31 January 2019

Channel 9 Willoughby – Modification of Concept Approval  
MP 10\_0198 MOD 2

**Figure 3 – Layout Comparison - Approved Layout (top) – Proposed Layout (bottom)**

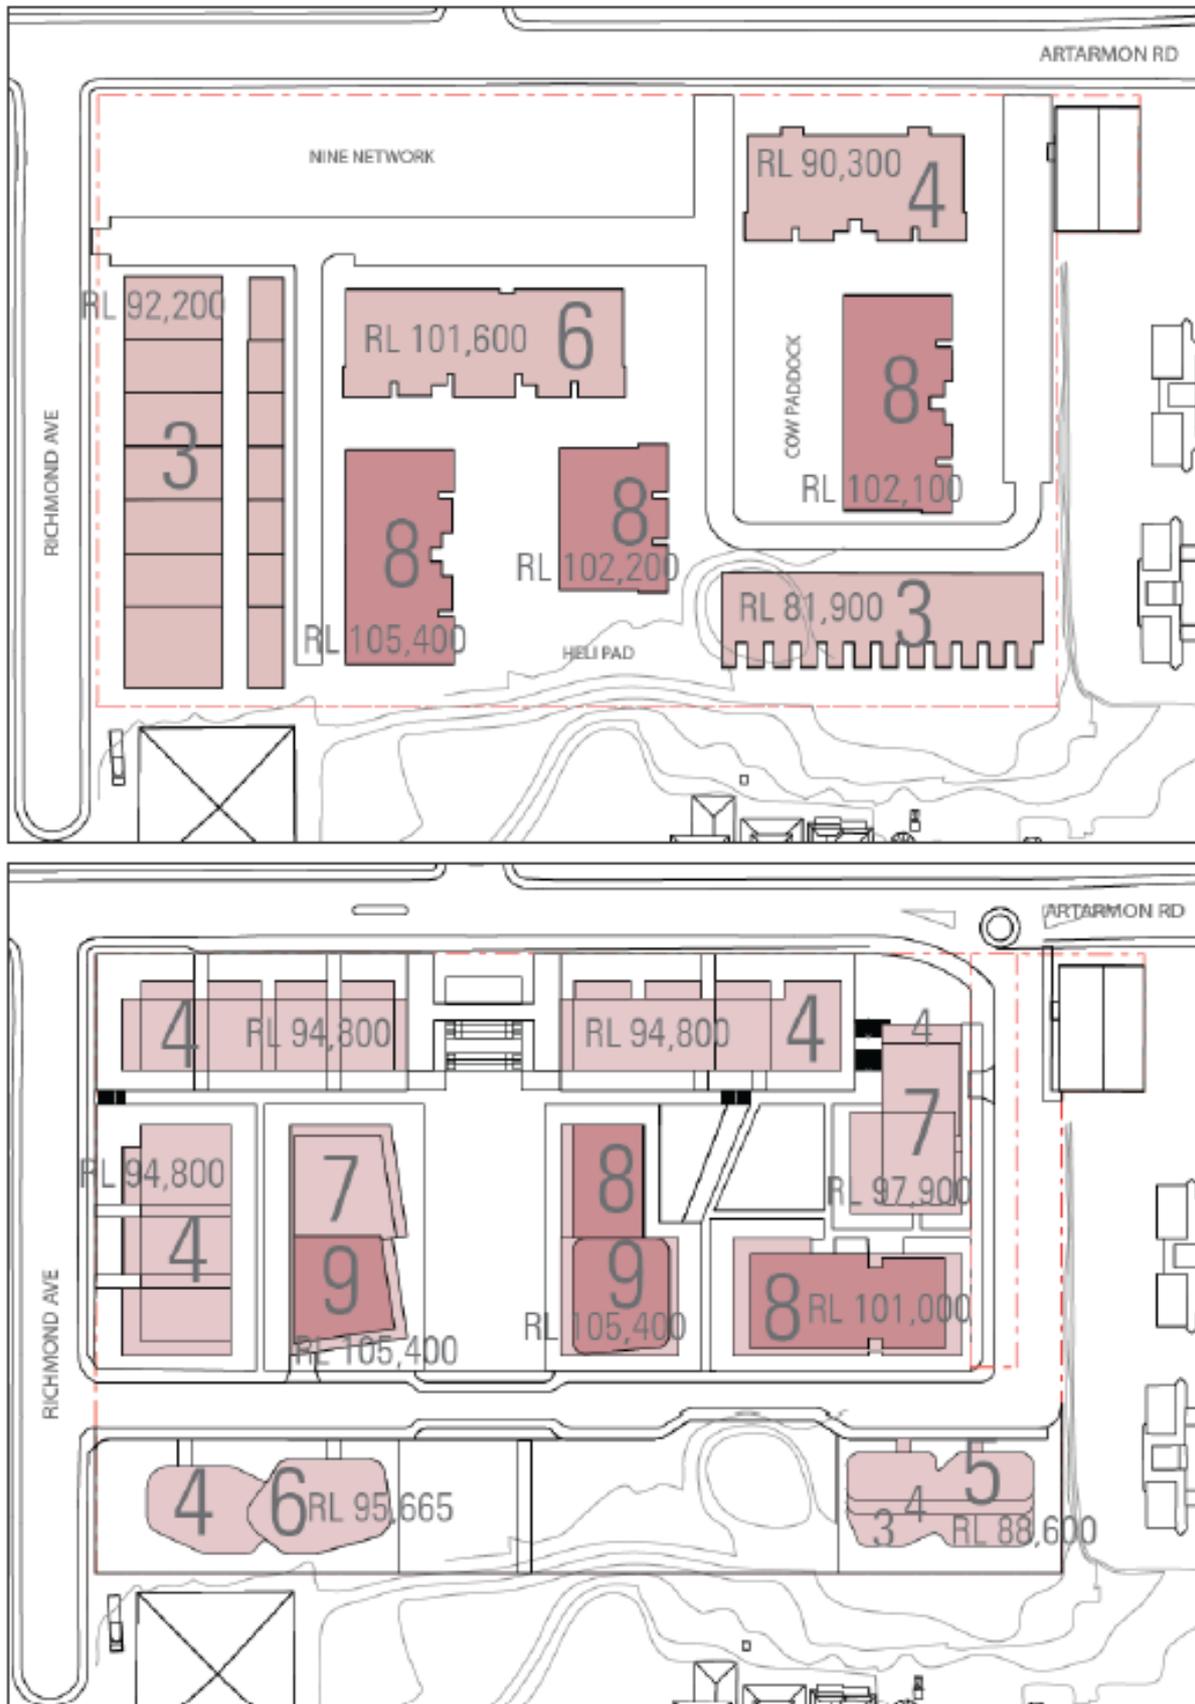
37. The proponent undertook an assessment of the Application's built form in both its EAR and RtS. Illustration of the approved and proposed site layout is included as Figure 3.

*“The proposal as exhibited sought to increase the maximum envelope height for Buildings D and E to 11 and 12 storeys (RL 113.3 and RL 116.2) respectively, which would exceed the maximum height of eight storeys and RL 105.4 established under the concept approval.”*

*“... the Department agrees with the concerns raised in the public submissions and by Council about his additional height, and required the Proponent to reduce the height of Buildings D and E to be consistent with the maximum height established by the PAC and LEC”.*

*“The proposal seeks to alter how the development presents along the site edges in terms of building envelope height. The concept approval included three storey envelopes adjacent to the southern boundary and Richmond Avenue, with publicly accessible open space and a four storey residential flat building adjacent to Artarmon Road.”*

*“The proposal seeks to provide a more uniform four storey built form along Richmond Avenue and Artarmon Road, with a built form of up to six storeys along the southern boundary”.*

*“The Department supports the proposed building heights along the site edges/ street frontages, as:*

- the proposed four storey envelopes along Artarmon Road and Richmond Avenue are set back on the upper floor, which also assists in the scale transition to the lower scale buildings to the north and west of the site and reduces the visual appearance of the buildings when viewed from the surrounding public domain*

- the amended layout relocates the open space from the corner of Artarmon Road/ Richmond Avenue centrally within the site (creating a view corridor from Edward Street) and providing an opportunity for a new four storey building on this corner that reinstates the rhythm of buildings that respond to the street layout*

- the proposed increase in height from 8 to 9 stories is for 2 buildings located in the centre of the site. They are within the Concept Plan height limit of RL105.4. The change in RL level along Artarmon Road from 90.30 to 94.80 and along Richmond Avenue from 92.20 to 94.80, provides a transition in the context of the surrounding urban environment;

- the setbacks of the top floors of the buildings to Richmond Avenue, Artarmon Road and the public domain provide further articulation and transition from the low scale surrounding properties, notwithstanding the loss of the public open space at the corner of Artarmon Road and Richmond Avenue;
